Re: SEAA 2106 - McKewen Ditch Measuring Device Notice

<p>In The Matter Of:</p> <p>McEwen Ditch Company</p> <p>RESPONDENT</p>	<p><b>McEwen Ditch</b></p> <p><b>MEASURING DEVICE NOTICE</b></p> <p><b>SEAA 2106</b></p> <p>DISTRIBUTION ACCOUNT: 102196</p> <p>WATER RIGHTS: 61-2018</p>
--	---

# McKewen Diversion

## *Stilling Well Specifications*

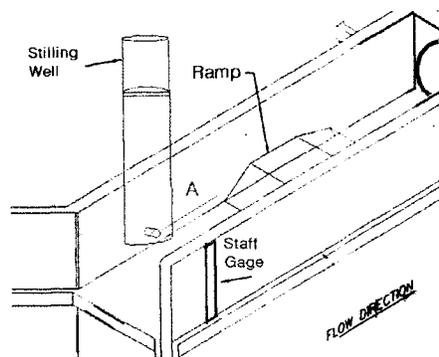
- 12" diameter minimum
- Half circle shelf attached 1' down from the top of the stilling well
- Need at least 1' of height between top of flume and shelf (if the flume is 2' high then stilling well should be at least 4')
- Floor that is sealed (water tight)
- Lid that can be locked
- Stilling well inlet and staff gage need to be properly located in the flume.
  - Parshall Flume – Inlet must be at  $\frac{2}{3}$  of the converging section length (away from the throat)

- Ramp flume – Inlet must be upstream of the ramp at least 2 times the height of the water over the ramp sill.

- The stilling well is typically connected to the flume by a small diameter pipe. Want to use a pipe at least .75" in diameter and ensure that it's sealed (water tight). 2" pipe is ideal because it's big enough to flush sediment out.

- The pipe connection between the stilling well wall and flume wall should be perpendicular and carefully cut flush with the inside walls of the well and flume.
- The pipe opening should also be located close to the floor of the flume so that small flows through the flume are still measurable in the stilling well.
